Staff Report

File #: LN-16

FS 103 SITE FLEX

Request: Commercial Flex
P&Z# 20-05000004
Owner: Whitney LLC, 40th Street LLC, Clermont Realty LLC & Newtown Hall, LLC
Project Location: 3500 NE 16th Terrace
Folio Number: 484224190060
Land Use Designation: CF
Zoning District: CF
Commission District: 2
Agent: Christina Bilenki (561-405-3323)
Project Planner: Jean Dolan (954-786-4045) / jean.dolan@copbfl.com

SHEET TITLE:
SITE PLAN
 SHEET NUMBER:
SP-1

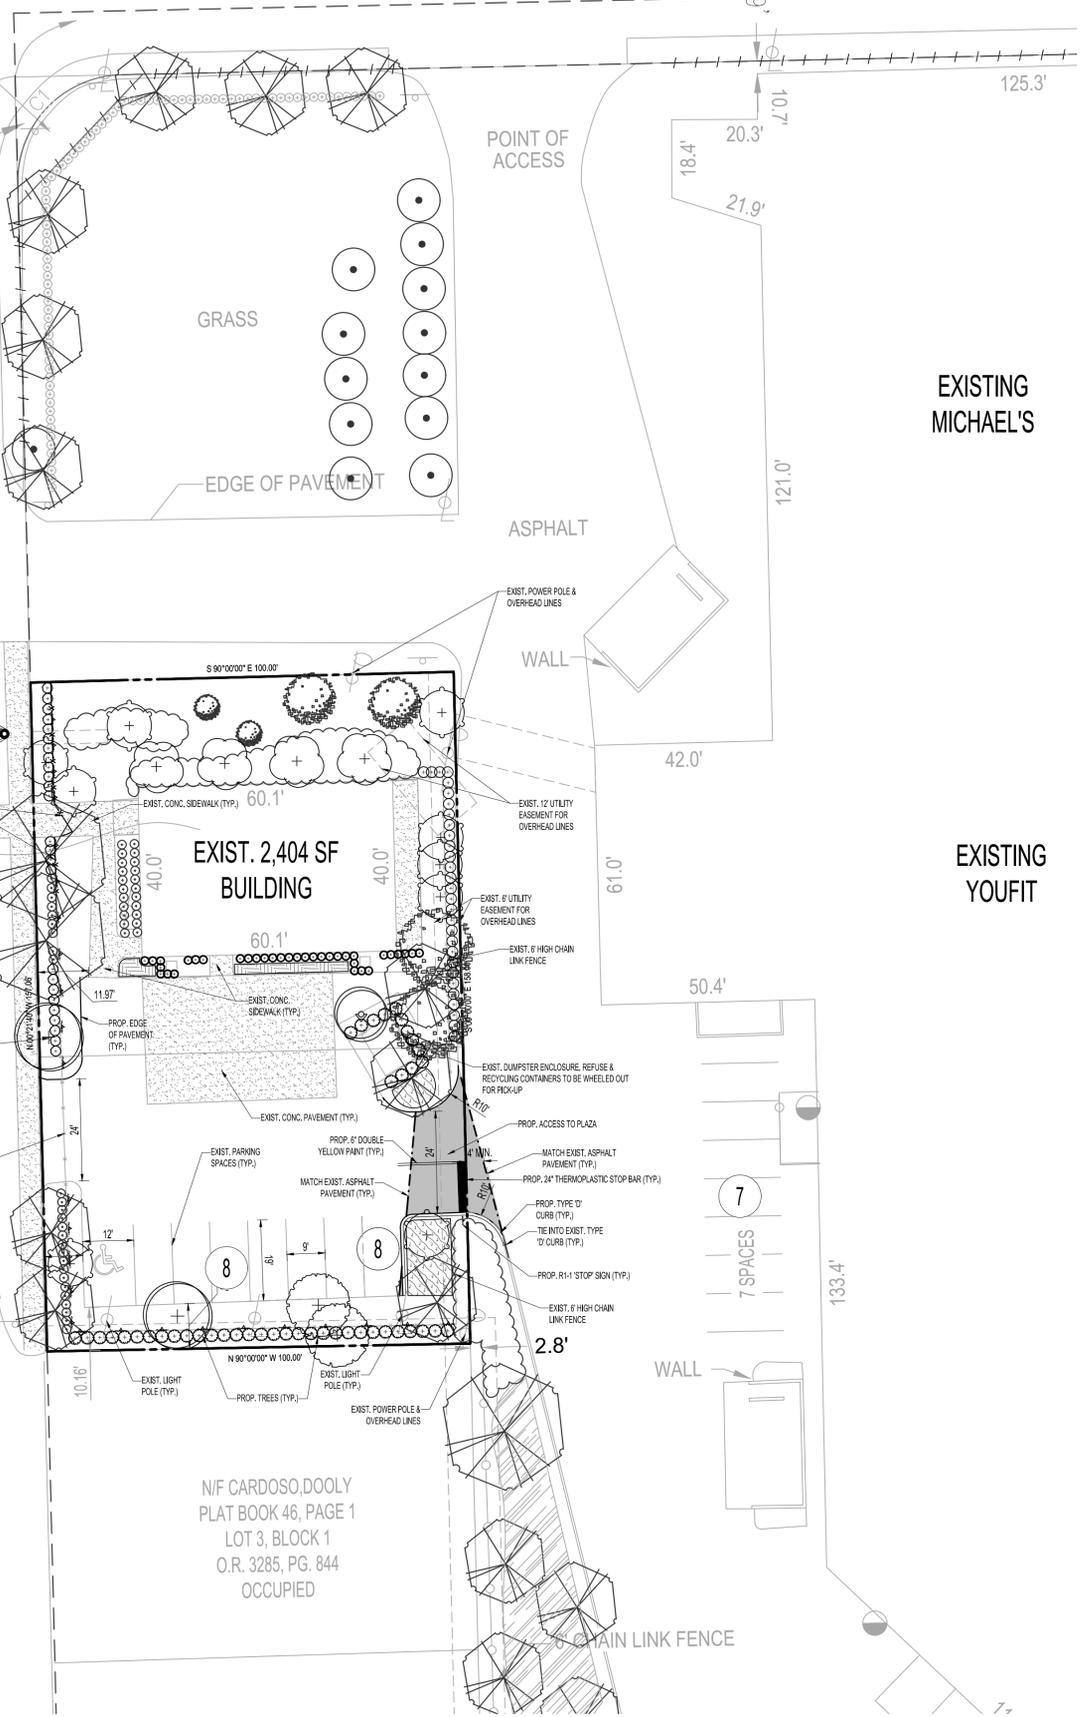
The site plan ultimately approved for this site shall be generally consistent in regard to building dimensions and placement, setbacks and buffering with the Conceptual Plan (Attachment 1). The following revisions must be made to the Conceptual Plan before this request will be placed on a City Commission agenda:

- (1) The perimeter buffer along the south and west property lines must be at least 10 feet wide.
- (2) Label the south and west fence as follows: "Existing fence to be removed and replaced with a semi-opaque fence and gate".
- (3) Add the required shrubs on the interior side of the semi-opaque wall/fence.
- (4) Discuss with staff the areas requiring installation of a type D curb.
- (5) Add a note to the west-side gate on NE 16 Terrace as follows: "To remain locked except for emergency access and trash pickup."
